REF	QTY	PART or DRWG No.	DESCRIPTION	MATERIAL
PARTS and MATERIAL LIST				
LIGO CALIFORNIA INSTITUTE OF TECHNOLOGY MASSACHUSETTS INSTITUTE OF TECHNOLOGY				
PLATE, MIRROR MOUNTING				
C		ADD .375 TO LENGTH	kenm	8-2-99
B		FOR FABRICATION	kenm	6-2-99
00		PRE-RELEASE	CHAPUT	11-8-98
REV		DESCRIPTION	DCN NUMBER	APPR'D CHECK DRWN DATE
MATERIAL: 6061 T-6 ALUM			HEAT TREAT: /	FINISH: /
DWG. NO.		DESCRIPTION		CAD FILE
REFERENCE DRAWINGS		USED ON: XXX		D980641-C
		NEXT ASS'Y: XXX		SIZE
				C
				DWG. NO.
				D980641-C
				SCALE
				FULL
				SHEET
				10F1

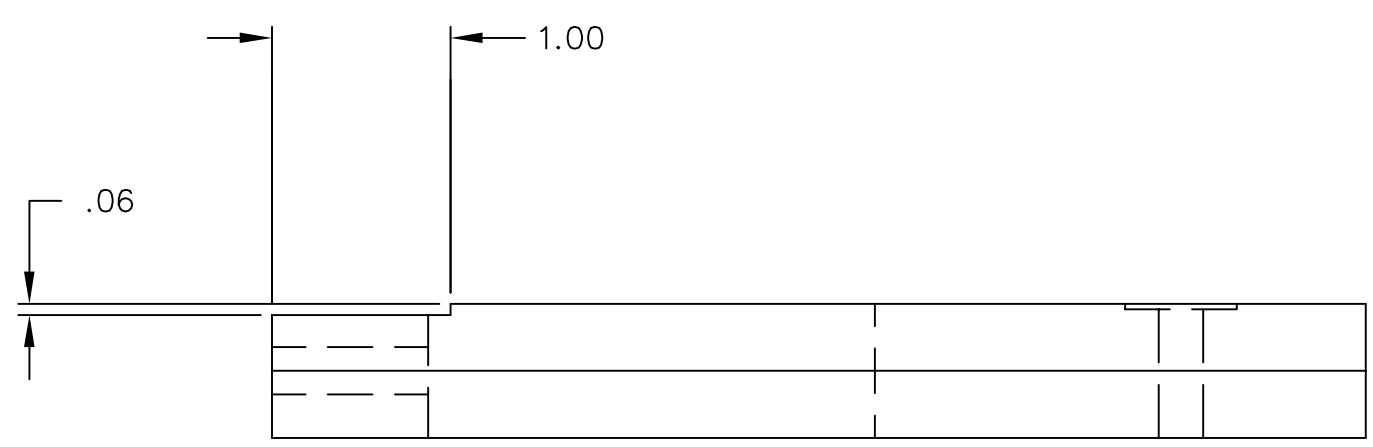
A1,  
 ref. \_ revision 'C' length  
 shown is .37" longer  
 than Rev. 'B'
